INDICATING/RECORDING SYSTEMS - COCKPIT OVERHEAD DIMMING POTENTIOMETER REPLACEMENT

The 22M185 Dimming Potentiometer in the cockpit overhead is obsolete.

MTB-31-04
Page 1 of 6

Figure 1. Dim Potentiometer Installation (Sheet 1)

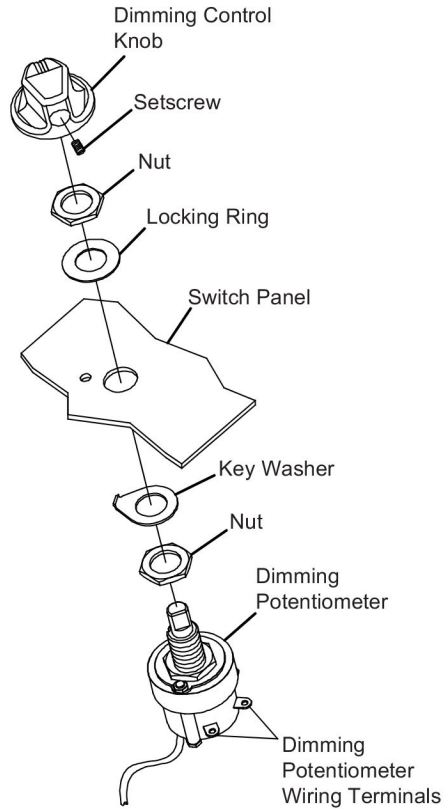
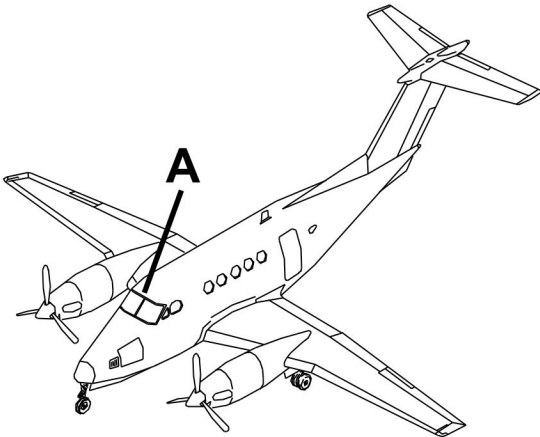
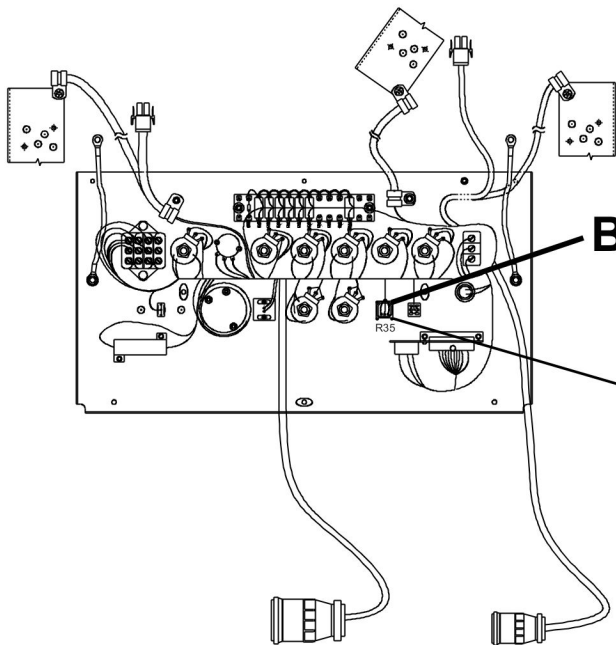
2. (Refer to Figure 1, Sheet 1.) Remove and retain the setscrew from the dimming control knob.
 - A. Keep the dimming control knob.
3. Remove the nut and the locking ring that attach the 22M185 Dimming Potentiometer to the overhead panel assembly.

- 22M185 Dimming Potentiometer (R35) (Discard)
- L11756 Dimming Potentiometer (R35) (1 Required)

Figure 1. Dim Potentiometer Installation (Sheet 2)

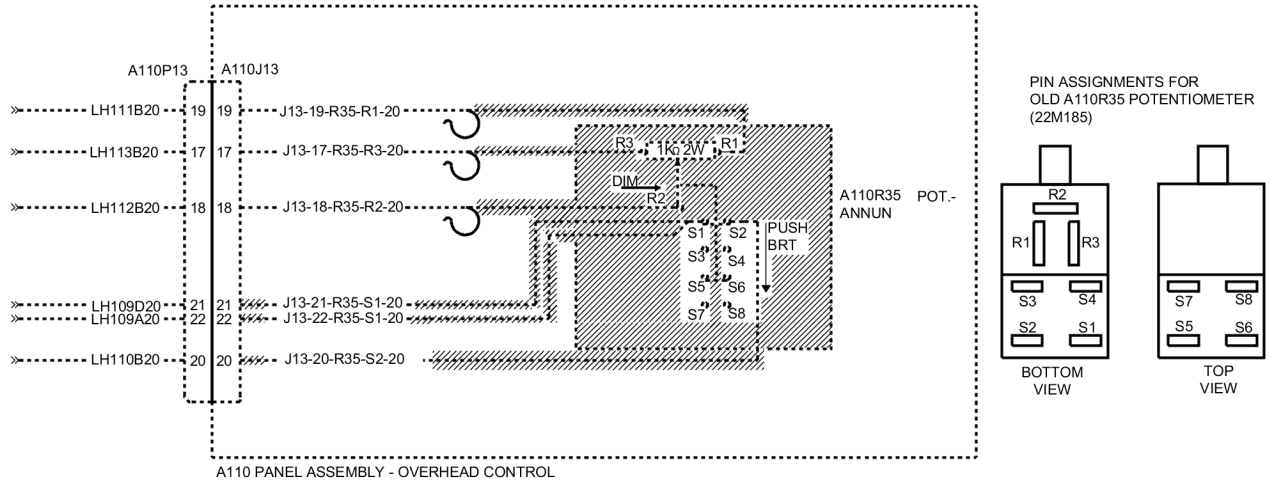
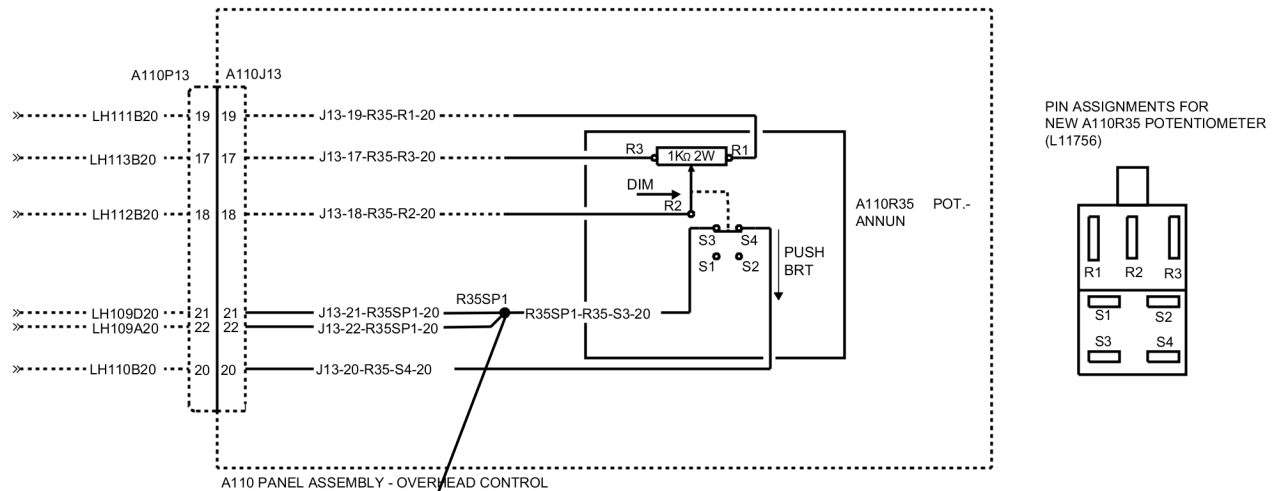
- B. Use a soldering iron to disconnect the wires from the dimming potentiometer terminals.
8. Remove the nut and the key washer from the 22M185 Dimming Potentiometer.
9. Remove and discard the 22M185 Dimming Potentiometer from the airplane.
10. (Refer to Figure 1, Sheet 2.) Do the wiring changes as follows:
 - A. Install one M81824/1-2 Splice on the J13-21-R35SP1-20 Electrical Wire and the J13-22-R35SP1-20 Electrical Wire. (Refer to the King Air Standard Practice Chapter 20 – Airframe, Electrical Wiring – Maintenance Practices).
 - B. Using a heat gun, install the 106242G44 Heat Shrink Tubing over the electrical wires.
11. Connect the new L11756 Dimming Potentiometer to the wire bundle assembly as follows:
 - A. Identify the wires and the terminals on the dimming potentiometer.

M81824/1-2
 Splice
 (1 Required)
